# **Draft Regulatory Guide Comments Meeting: *AREVA Hydrogen Model Perspectives***

Lisa Gerken  
April 30, 2014

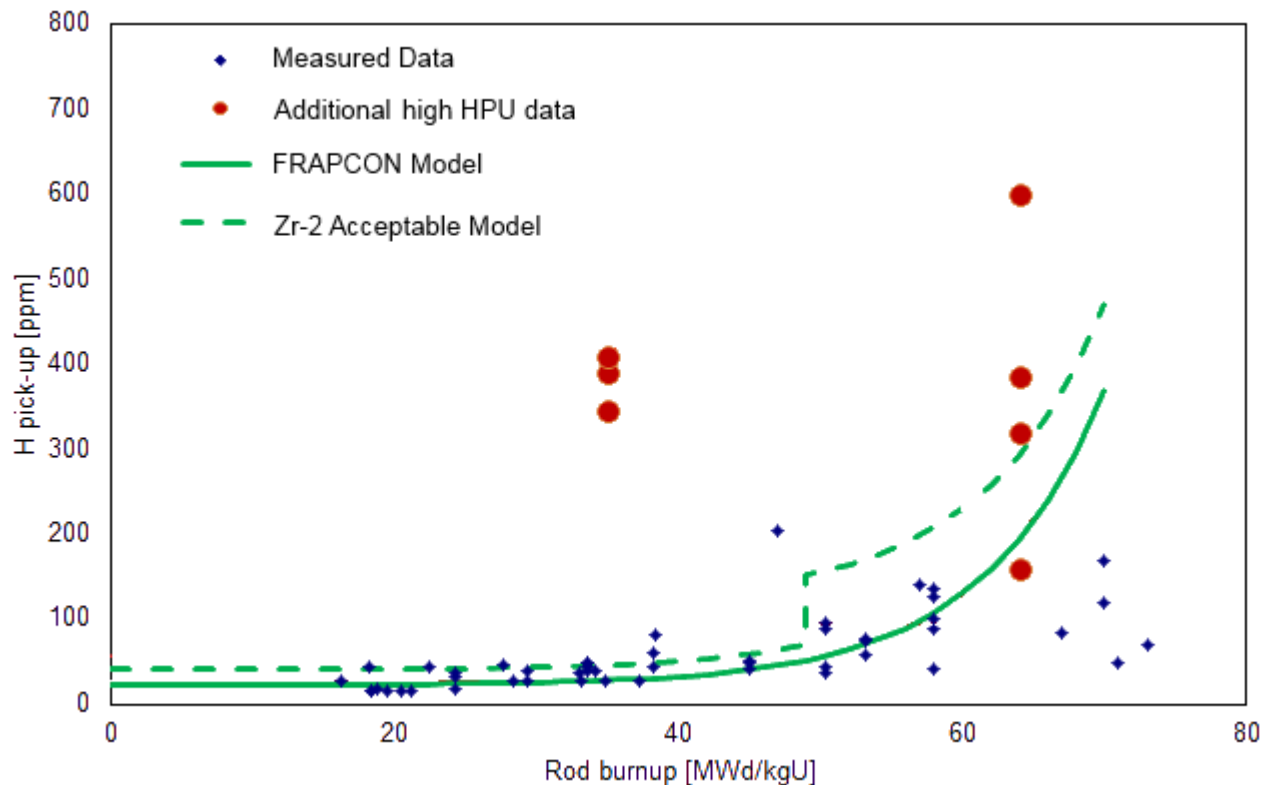
### ◆ The PNNL model is relatively recent, but does not include more recent data published by AREVA and WES

### ◆ Additional data showed enhanced HPU in certain conditions

- Enhanced HPU is correlated with high/low power histories
- Increased HPU even at medium burnups of ~40 GWd/MTU
- Phenomenon causes difficulties for direct burnup-to-hydrogen content correlation

- ◆ Red points display the additional high HPU data
